Re: Initial Submission Review: Green Valley Ranch East – Tibet Road Preliminary Plat – Minor Amendment 1
Case Number: 2021-6018-01

On behalf of Oakwood Homes and Terracina Design, we have reviewed the comments dated November, 23 2022. The following is a response to comments.

N. TIBET ROAD - TRIBUTARY T TO 48TH AVENUE INFRASTRUCTURE SITE PLAN

7 CRUSHER FINES BIKE PATH
SCALE: NTS

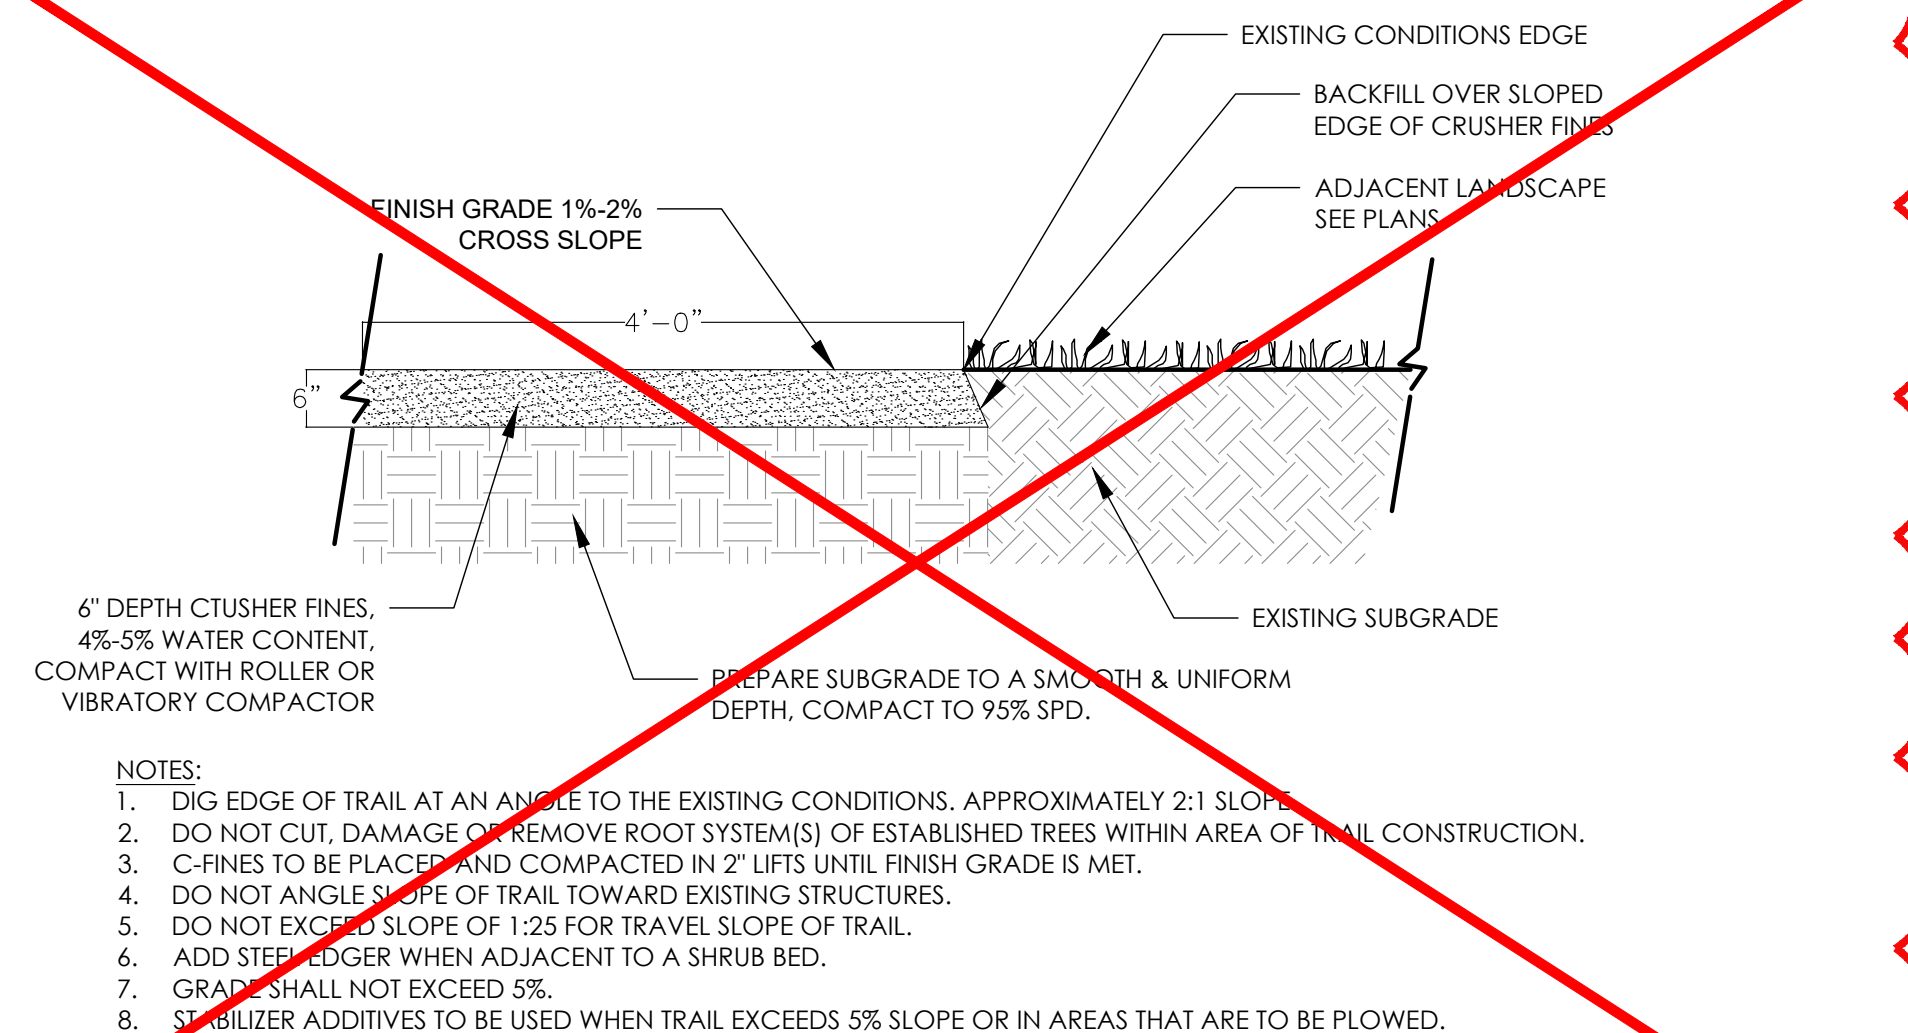
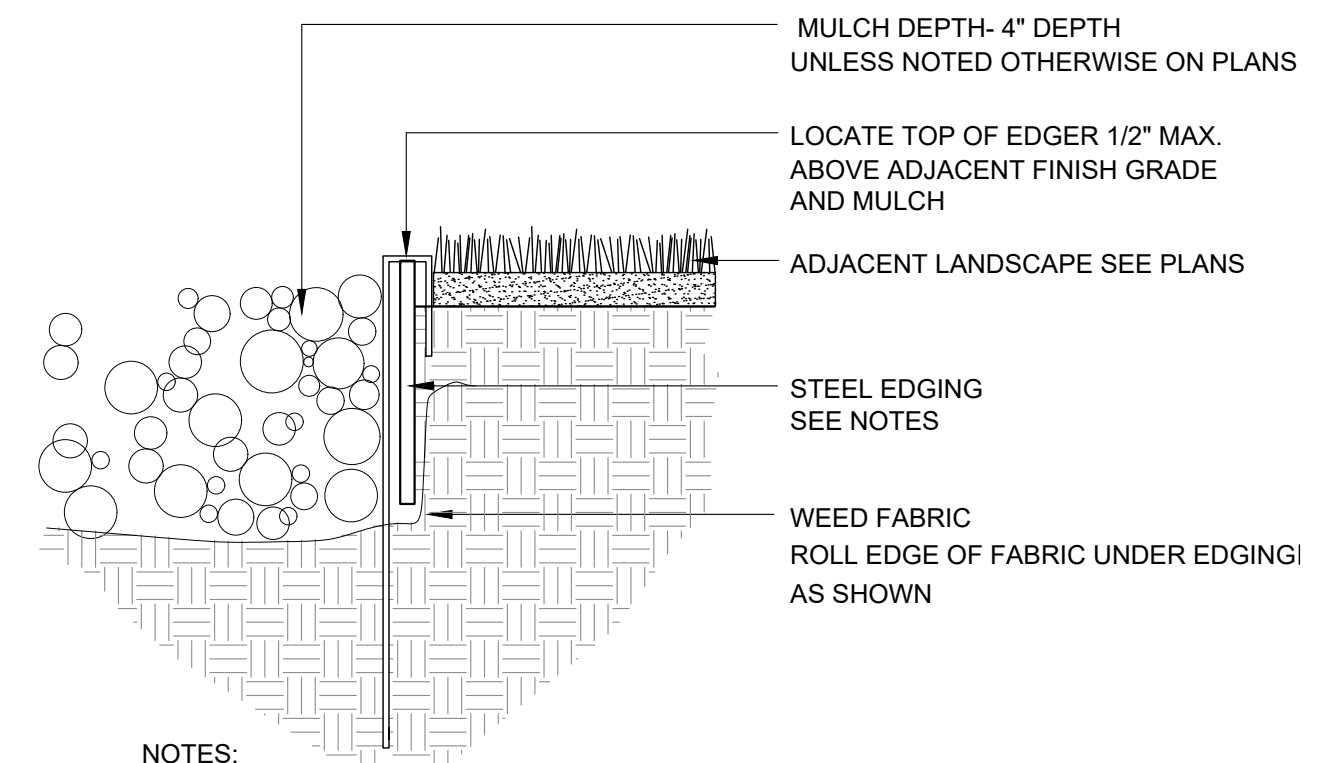
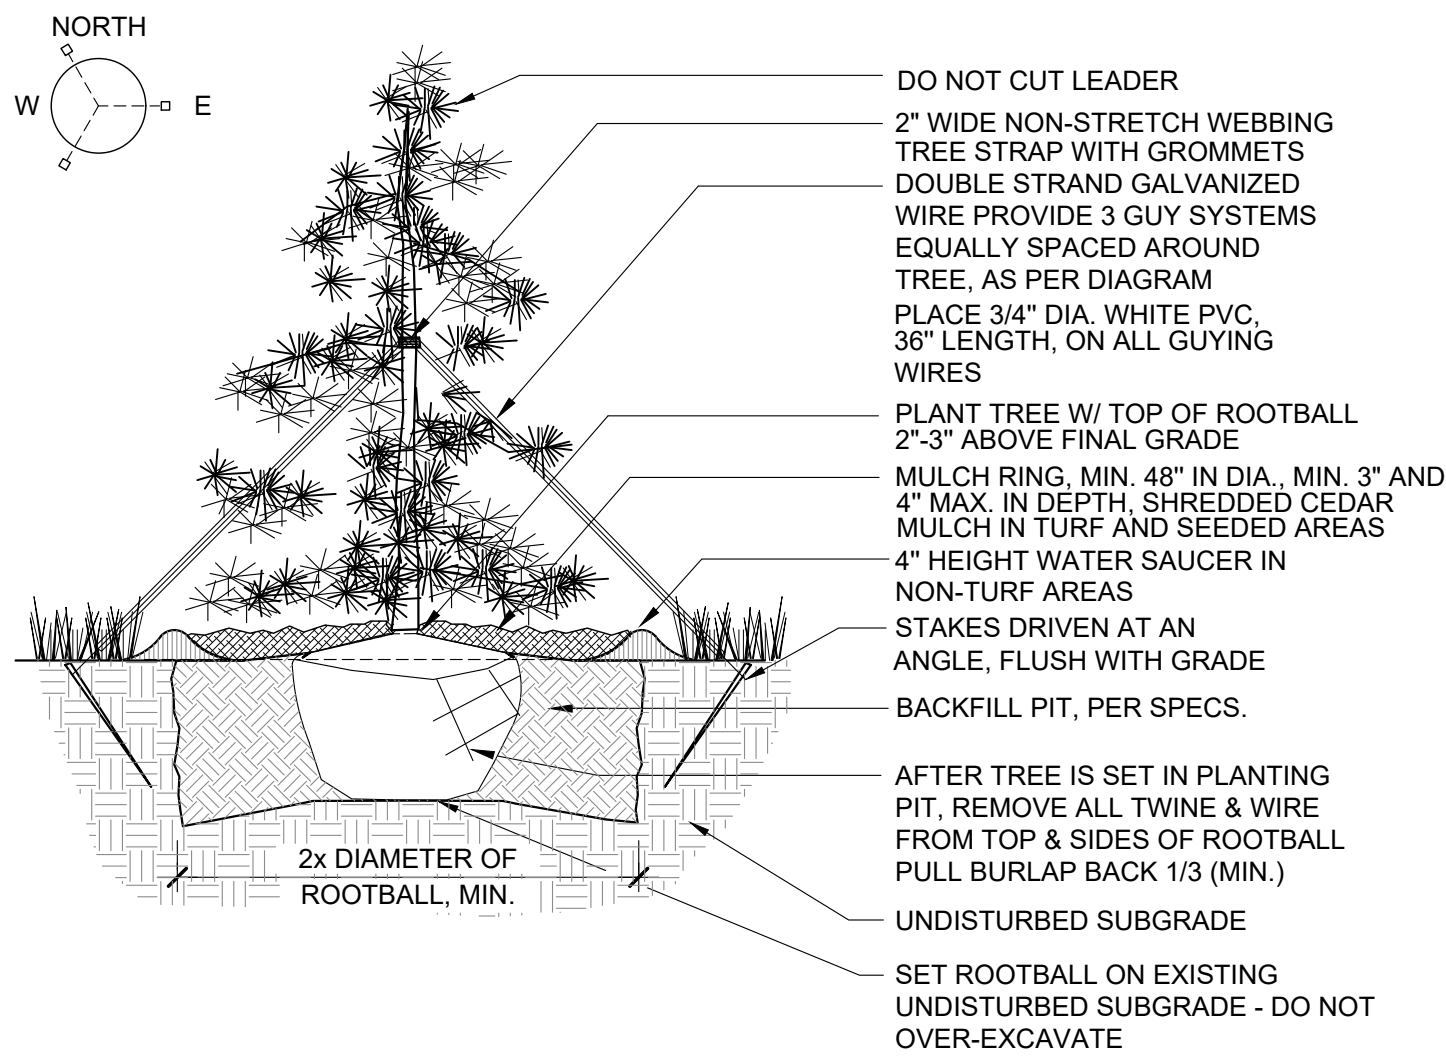
include a detail for the street light
